Planning Appeal

**Part change of use of site to retail to
allow public access to nursery**

**Poplar Cottage, Little Shaw Lane,
Markfield**

Highways Appeal Statement

Client
Garden Creation Services Ltd
Drawing No.
18.3588.04D

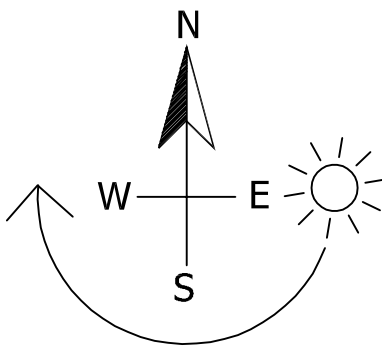
The internal layout of the site is detailed on David Granger drawing number 18.3558.04 Rev. D. This details 20 car parking spaces within the site. Based on the information available from the Applicant, it would appear that sufficient parking provision is proposed within the site.

Figure 1 – Site Location

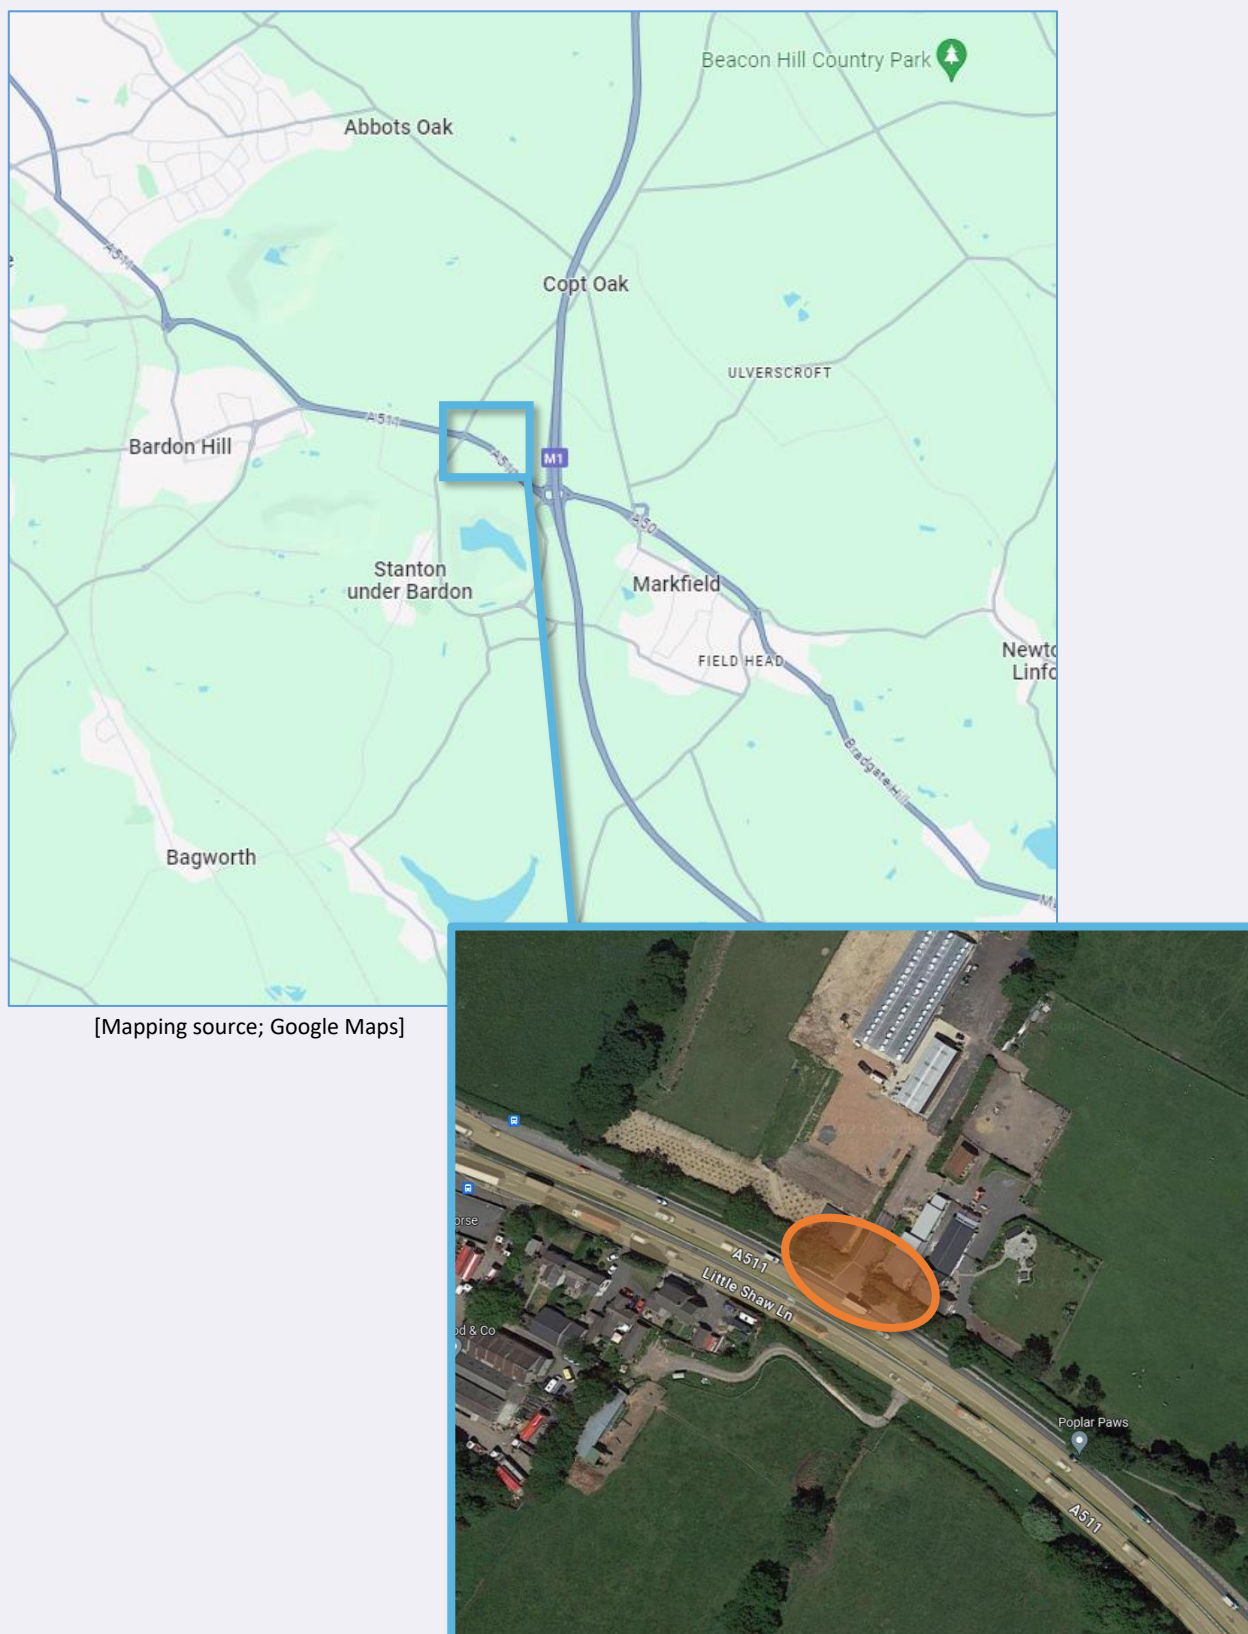
The site access is currently inconspicuous. The change to allow public access will result in some drivers who are unfamiliar with the site visiting. The lack of awareness of the site may result in hesitation and / or late braking, risking shunt type collisions on Little Shaw Lane.

The site was given permission in 2019 for use of the land for horticultural purposes, and therefore the access has been in regular use by vehicles associated with the horticultural traffic for a number of years and has not resulted in any highway safety problem. Leicestershire CC's own accident records show that there has not been a recorded personal injury accident at the access in the latest 5 years of data. It is
